STREET LIGHT IMPROVEMENTS FOR CENTRAL AVE. BETWEEN JOHN ST. AND LOCUST ST.

CITY OF ALBUQUERQUE
PUBLIC WORKS DEPARTMENT

AS BUILT INFORMATION

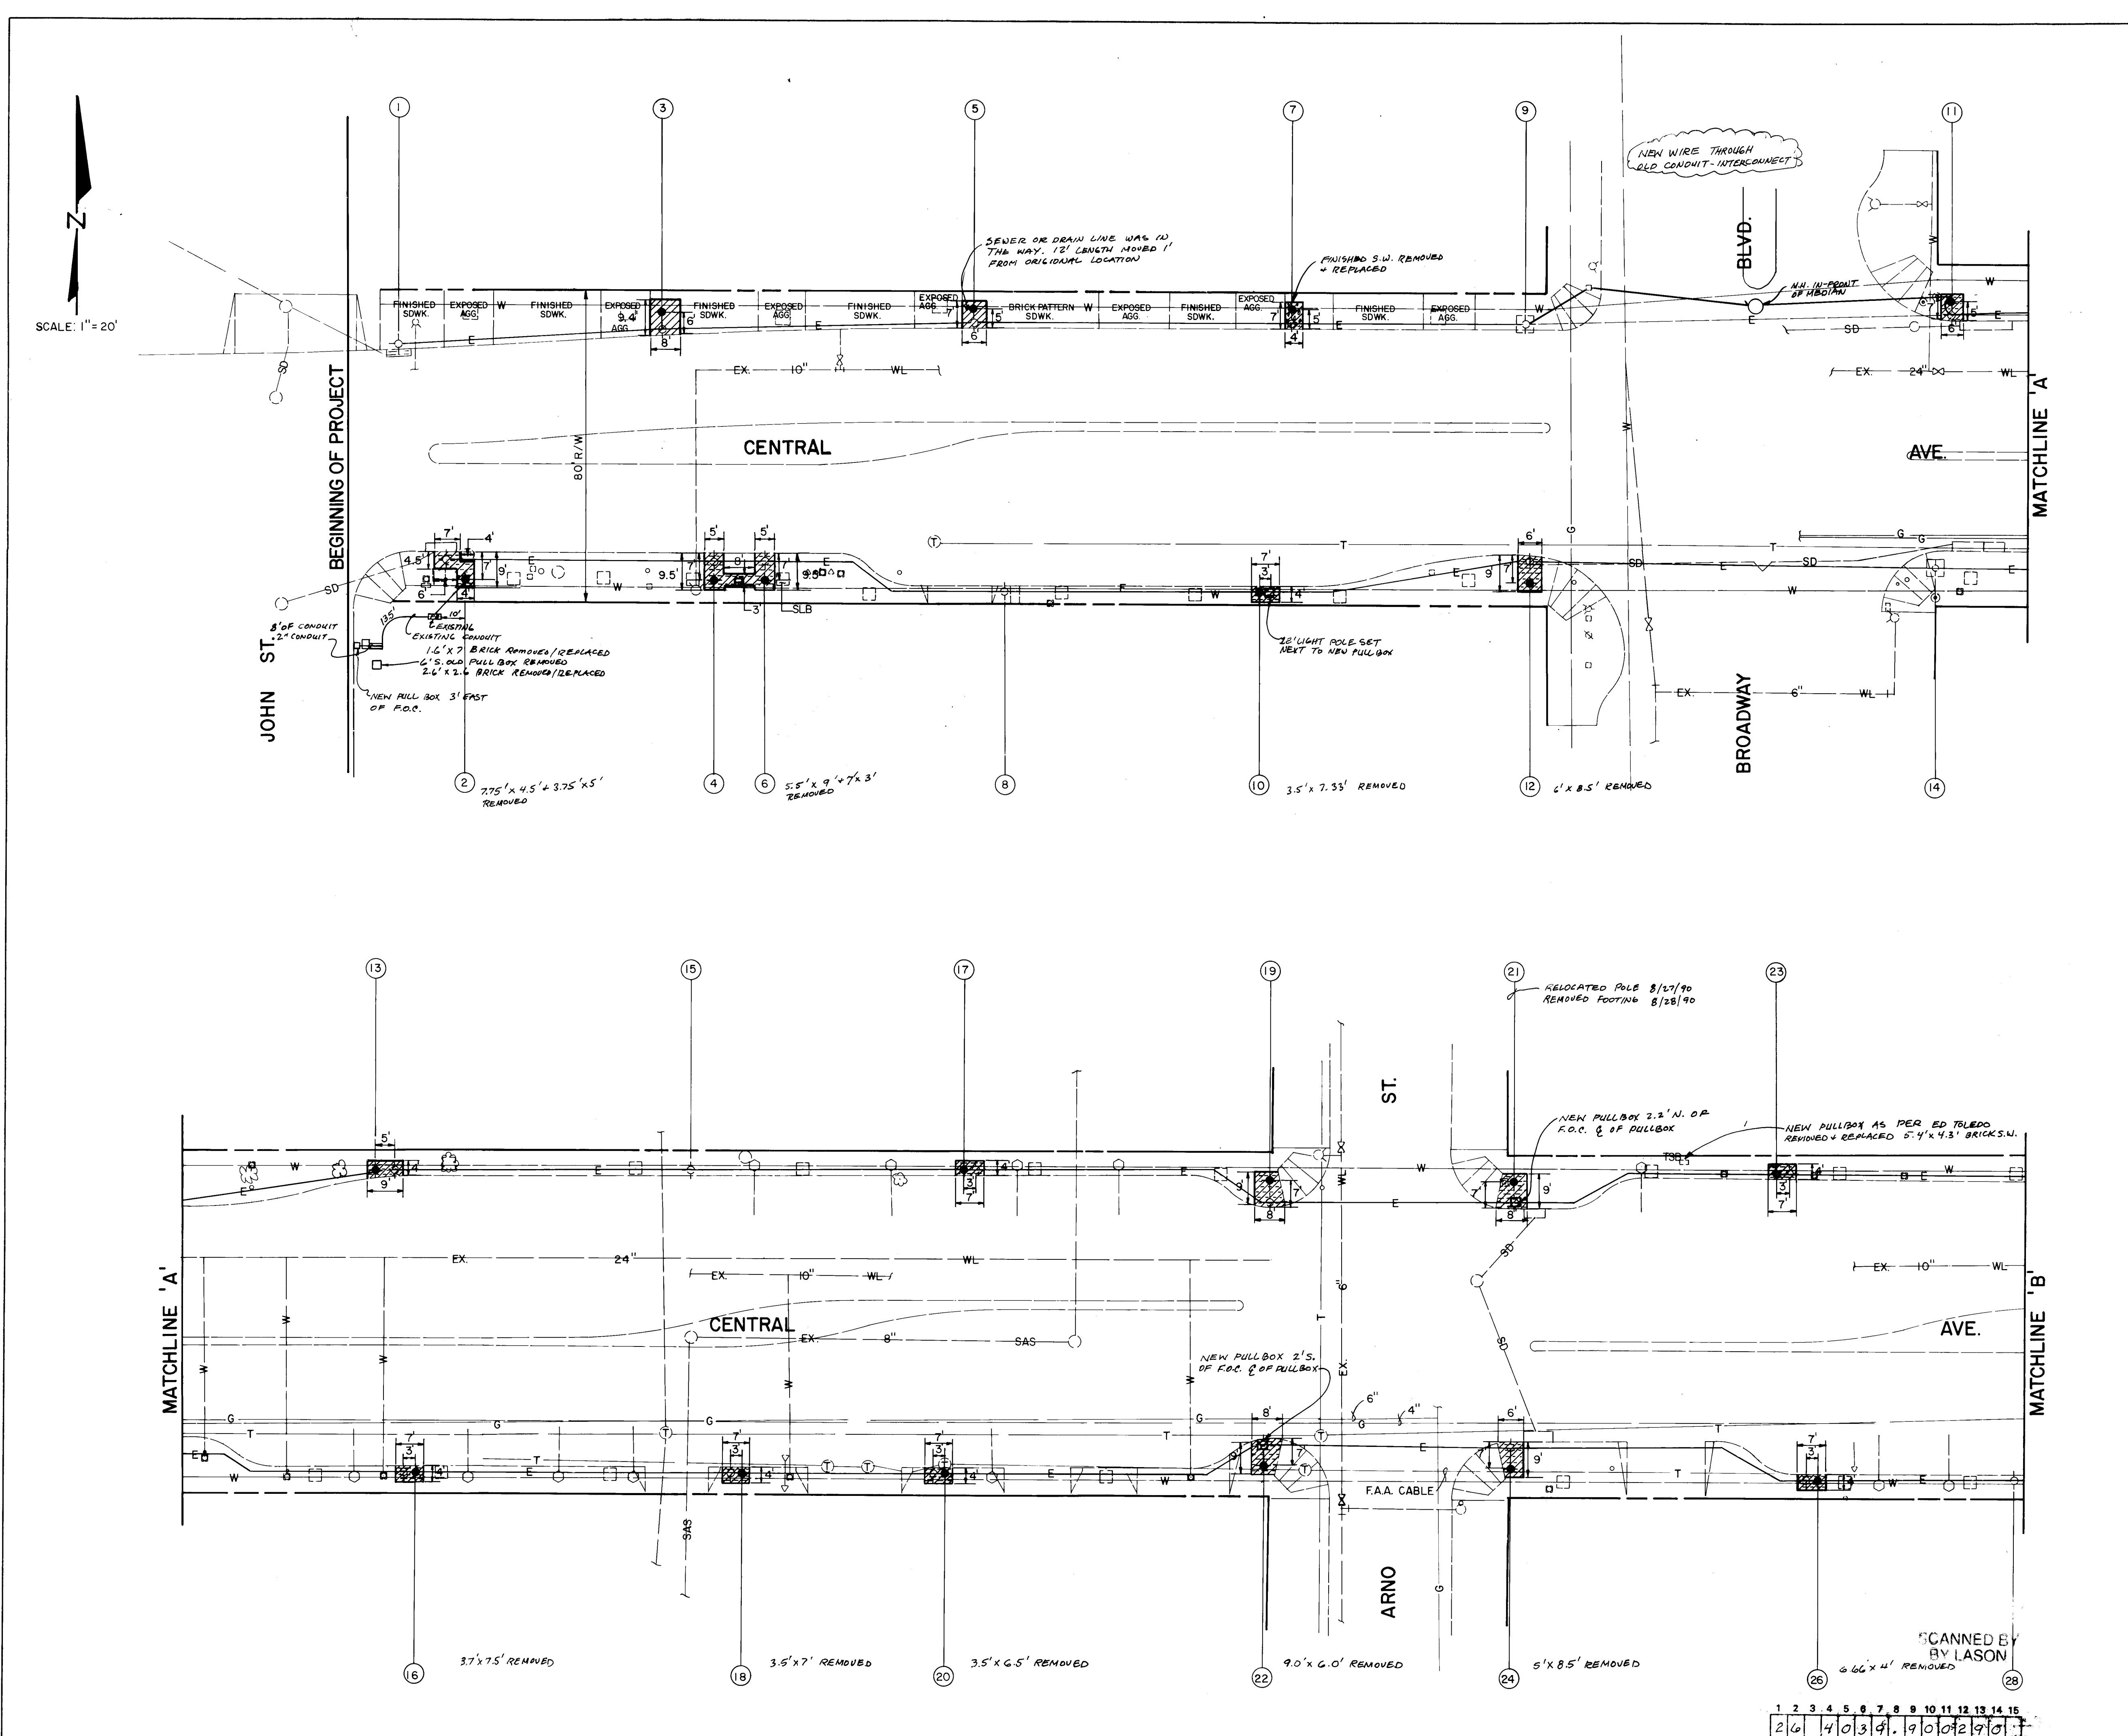
3. POLE MISSING, REMOVE EXISTING FOUNDATION. REMOVE AND REPLACE 8' x 9.4' FINISHED CONCRETE SIDEWALK. BUILD NEW PULL BOX AT OLD POLE LOCATION. BUILD NEW 12' POLE 6' FROM FACE OF CURB. REMOVED 9'x8' S.W.

5. REMOVE EXISTING POLE AND FOUNDATION. REMOVE AND REPLACE 7' x 6' BRICK SIDEWALK (MATCH EXISTING PATTERN). BUILD NEW PULL BOX AT OLD POLE LOCATION. BUILD NEW 12' POLE 5' FROM FACE OF CURB. REMOVED 6'x4'3\"/>

7. REMOVE EXISTING POLE AND FOUNDATION. REMOVE AND REPLACE 4' x 7' EXPOSED AGGREGATE SIDEWALK. BUILD NEW PULL BOX AT OLD POLE LOCATION. BUILD NEW 12' POLE 5' FROM FACE OF CURB. REMOVED 6'9\"/>

13. REMOVE EXISTING POLE AND FOUNDATION. REMOVE AND REPLACE 9' x 4' BRICK SIDEWALK. BUILD NEW PULL BOX AT OLD POLE LOCATION. BUILD NEW 12' POLE 5' DUE EAST FROM NEW PULL BOX AT 1.5' FROM FACE OF CURB. REMOVED 9'x4'3\"/>

17. REMOVE EXISTING POLE AND FOUNDATION. REMOVE AND REPLACE 4' x 7' BRICK SIDEWALK. BUILD NEW PULL BOX AT OLD POLE LOCATION. BUILD NEW 12' POLE 3' DUE WEST FROM NEW PULL BOX. REMOVED 8'x7'5\"/>

19. POLE MISSING, REMOVE EXISTING FOUNDATION. REMOVE AND REPLACE 8' x 9' BRICK SIDEWALK. BUILD NEW PULL BOX AT OLD POLE LOCATION. BUILD NEW 12' POLE 7' DUE NORTH FROM FACE OF CURB. REMOVED 8'x4'7\"/>

21. REMOVE EXISTING 30' POLE AND FOUNDATION. REMOVE AND REPLACE 8' x 9' BRICK SIDEWALK. BUILD TYPE 1 FOUNDATION 7' DUE NORTH FROM FACE OF CURB. RESET 30' POLE ON NEW FOUNDATION. REMOVED 6'10\"/>

23. REMOVE EXISTING POLE AND FOUNDATION. REMOVE AND REPLACE 4' x 7' BRICK SIDEWALK. BUILD NEW PULL BOX AT OLD POLE LOCATION. BUILD NEW 12' POLE 3' DUE WEST FROM NEW PULL BOX. REMOVED 4'x7\"/>

| SHEET 4 OF 8 | |

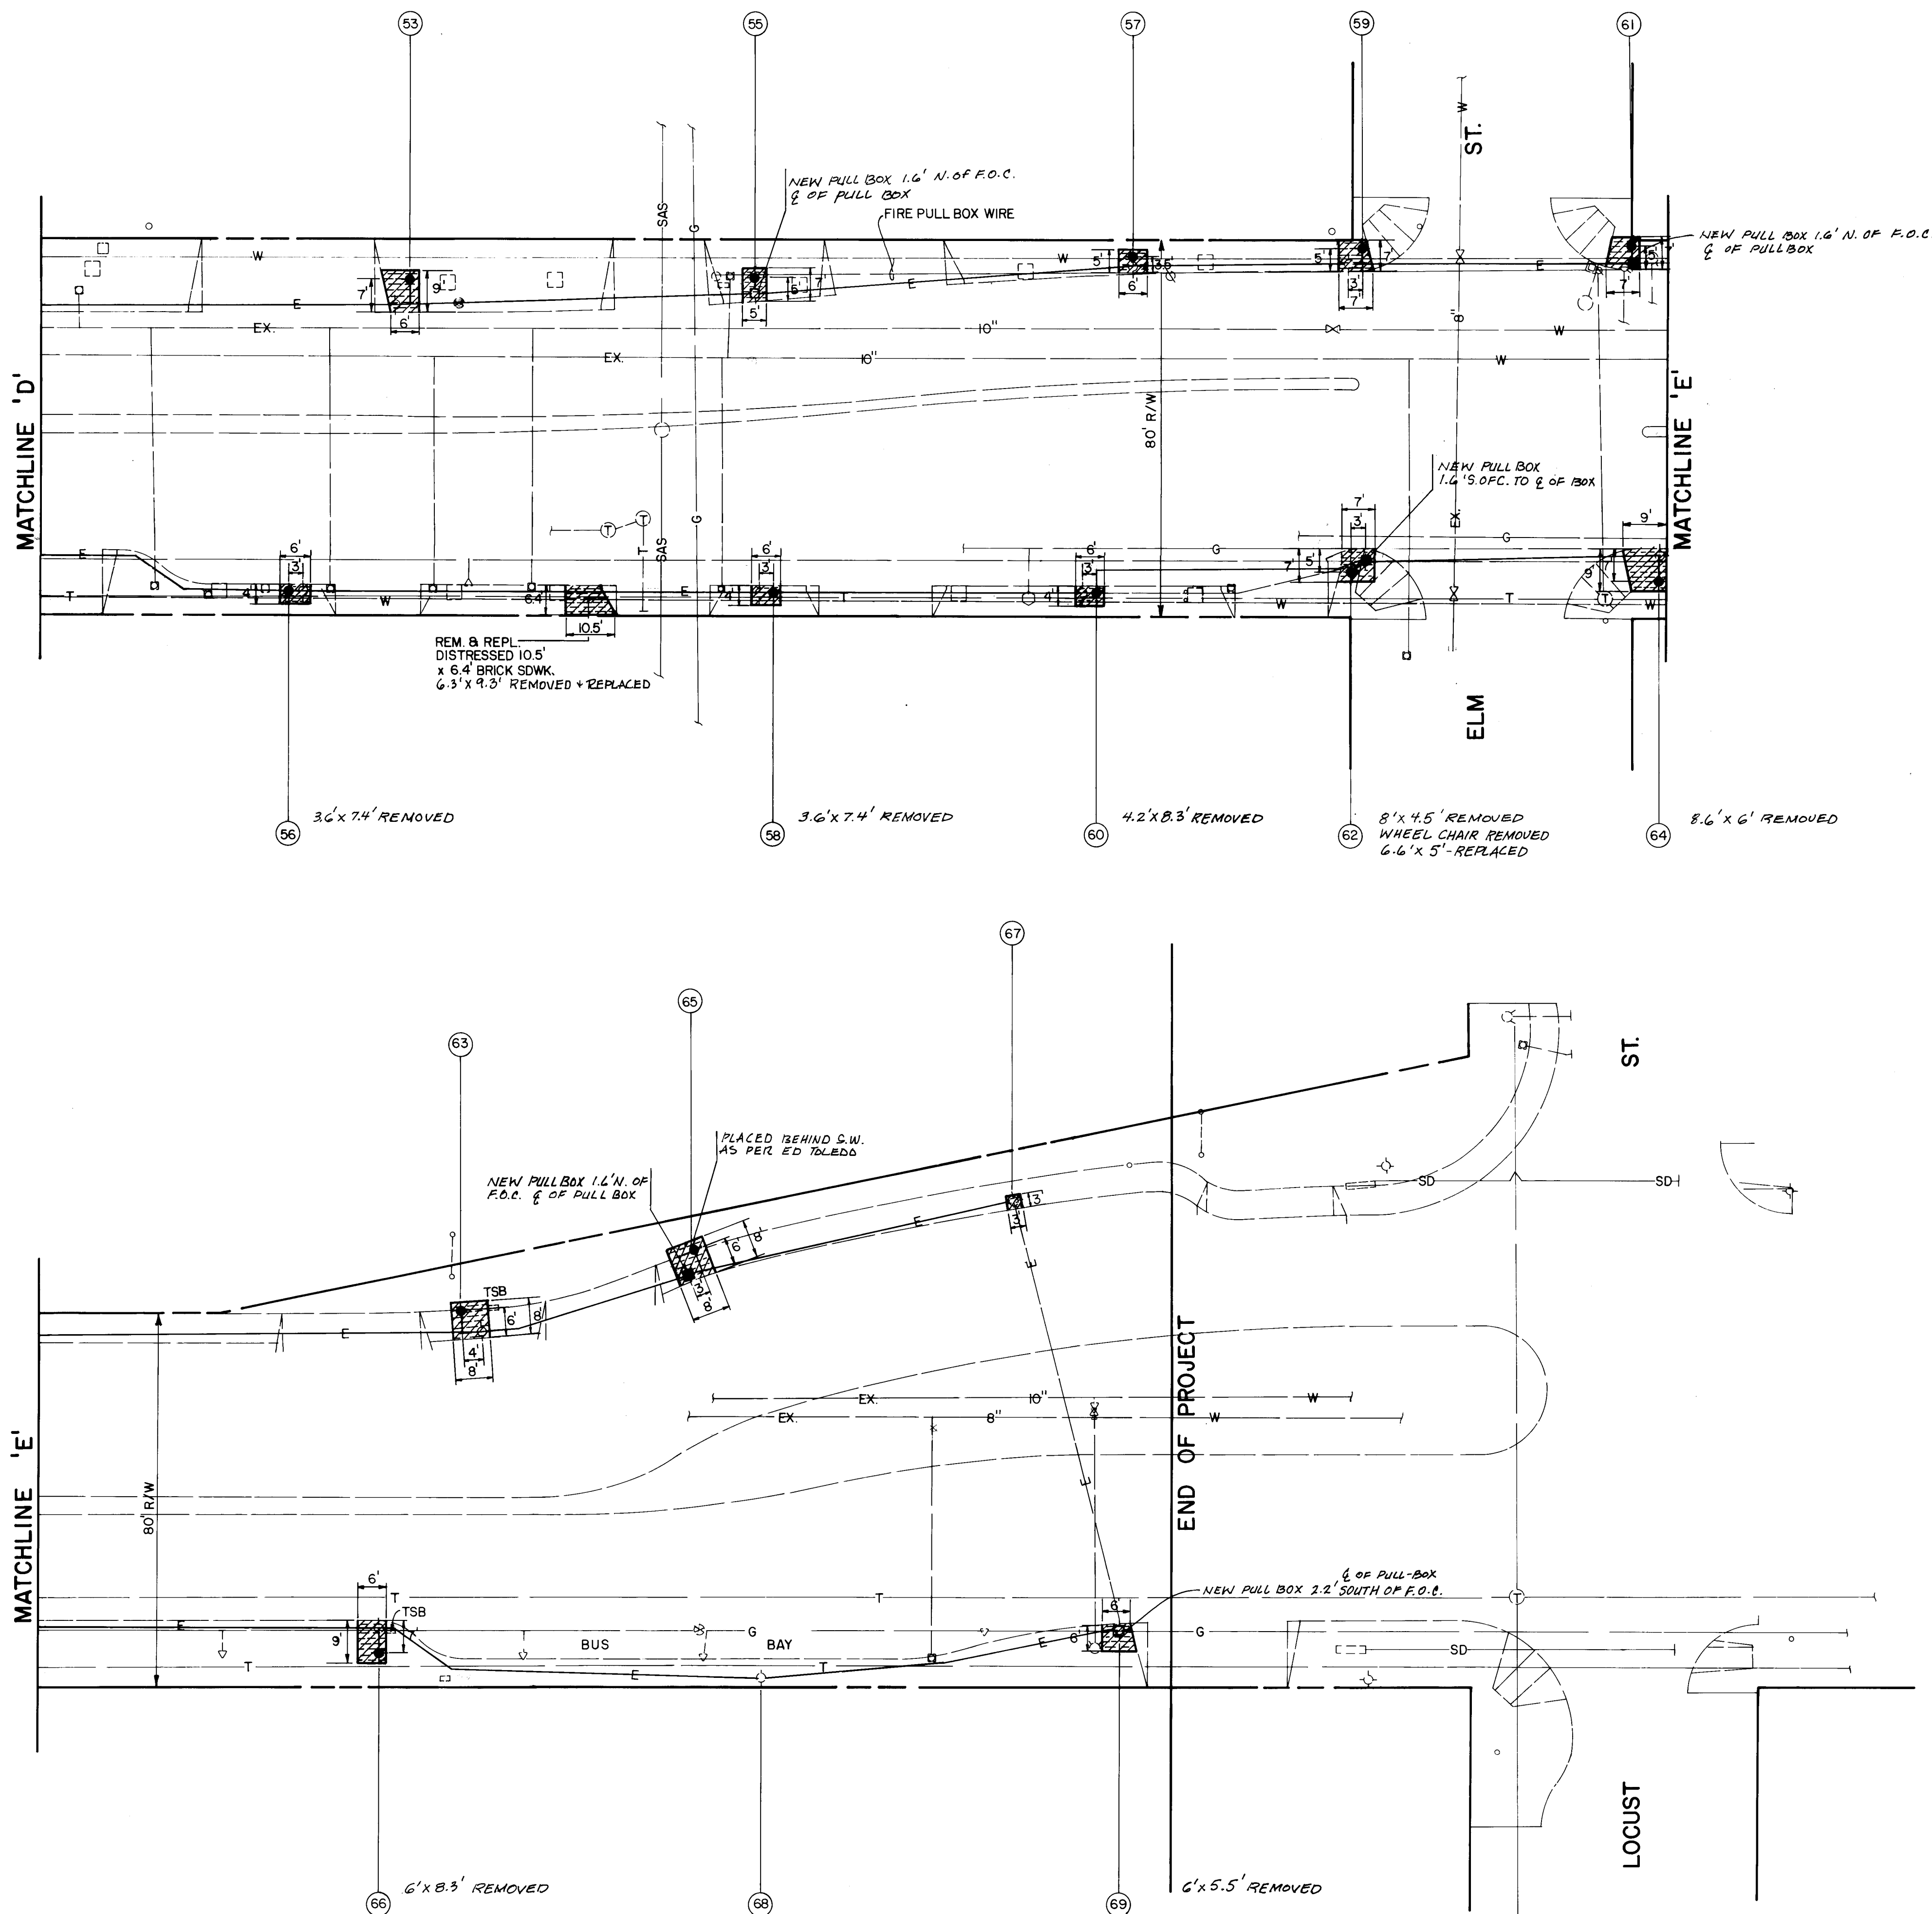
| CONSTRUCTION NOTES | |
|--------------------|---|
| 53. | POLY MISSING, (REMOVED 8/16/90) REMOVE AND REPLACE 4' x 8' BRICK SIDEWALK. BUILD NEW PULL BOX AT OLD POLY LOCATION. BUILD NEW 12' POLY 3' DUE EAST FROM NEW PULL BOX AND 7' FROM CURB FACE. 7' x 9' REMOVED. |
| 55. | POLY MISSING, (REMOVED 8/16/90) REMOVE AND REPLACE 4' x 8' BRICK SIDEWALK. BUILD NEW PULL BOX AT OLD POLY LOCATION. BUILD NEW 12' POLY 3' DUE EAST FROM NEW PULL BOX AND 7' FROM CURB FACE. 7' x 9' REMOVED. |
| 57. | REMOVE EXIST. POLY AND FOUNDATION. REMOVE AND REPLACE 4' x 8' BRICK SIDEWALK. BUILD NEW PULL BOX AT OLD POLY LOCATION. BUILD NEW 12' POLY 3' DUE EAST FROM NEW PULL BOX AND 1.5' FROM CURB FACE. (CAUTION: F.A.A. CABLE IN VICINITY OF STREET LIGHT WORK). 5' x 6' REMOVED. |
| 59. | POLY MISSING, (REMOVED 8/16/90) REMOVE AND REPLACE 4' x 8' BRICK SIDEWALK. BUILD NEW PULL BOX AT OLD POLY LOCATION. BUILD NEW 12' POLY 3' DUE NORTH AND 5' FROM CURB FACE. 7' x 6' REMOVED. |
| 61. | POLY MISSING, (REMOVED 8/16/90) REMOVE AND REPLACE 4' x 8' BRICK SIDEWALK. BUILD NEW PULL BOX AT OLD POLY LOCATION. BUILD NEW 12' POLY 3' DUE EAST FROM NEW PULL BOX AND 1.5' FROM CURB FACE. (CAUTION: F.A.A. CABLE IN VICINITY OF STREET LIGHT WORK). |
| 63. | POLY MISSING, (REMOVED 8/16/90) REMOVE AND REPLACE 4' x 8' BRICK SIDEWALK. BUILD NEW PULL BOX AT OLD POLY LOCATION. BUILD NEW 12' POLY 4' DUE WEST FROM NEW PULL BOX AND 6' FROM CURB FACE. 7' x 6' REMOVED. |
| 65. | POLY MISSING, (REMOVED 8/16/90) REMOVE AND REPLACE 4' x 8' BRICK SIDEWALK. BUILD TYPE 1 FOUNDATION 3' DUE EAST FROM OLD POLY LOCATION AND 6' FROM CURB FACE. BUILD NEW 30' POLY ON NEW FOUNDATION. 7' x 6' REMOVED. |
| 67. | POLY MISSING, (REMOVED 8/16/90) REMOVE AND REPLACE 3' x 3' BRICK SIDEWALK. SPLICE AND CONNECT CONDUIT AND WIRING. NO POLE REPLACEMENT. 3' x 5' REMOVED. |
